NOTE OF INFORMATION

To : All Bidders	Project : MTEC SNESI KONDRE
Date : 08 January 2025	Project # : EMSAGS-0824-C
	Discipline : Design & Engineering
	Ref. : MTEC-0824-C-MoM01

The site instruction for the project MTEC SNESI KONDRE was held on Wednesday 08 January 2025 at Snesikondre in the district Sipaliwini.

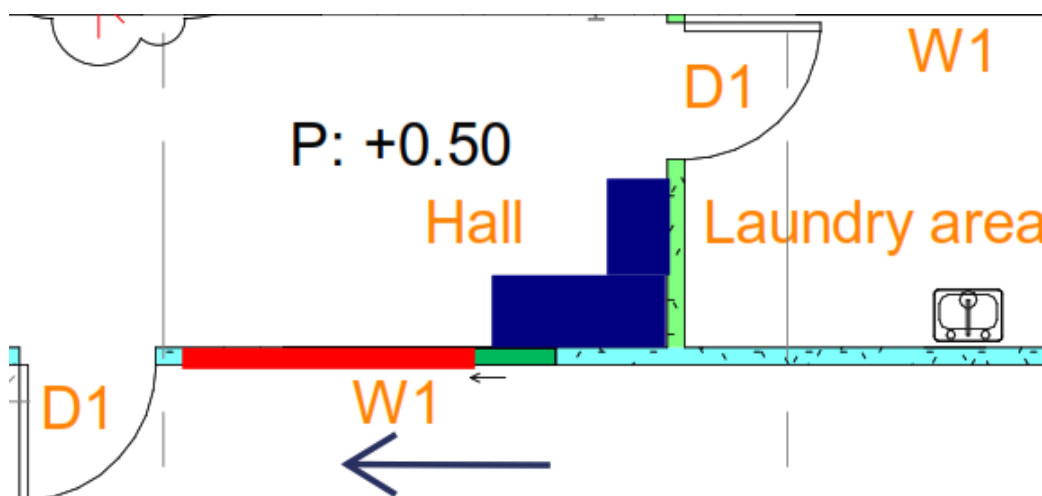
13. Is the Storage Room in the floor plan drawing of the electrical system intended for the Solar Installation?

Answer: No, the installation (in blue) will be done in the hall and the window (in green) will be moved towards the door (in red). Measurements to be checked onsite.

See picture for the location.
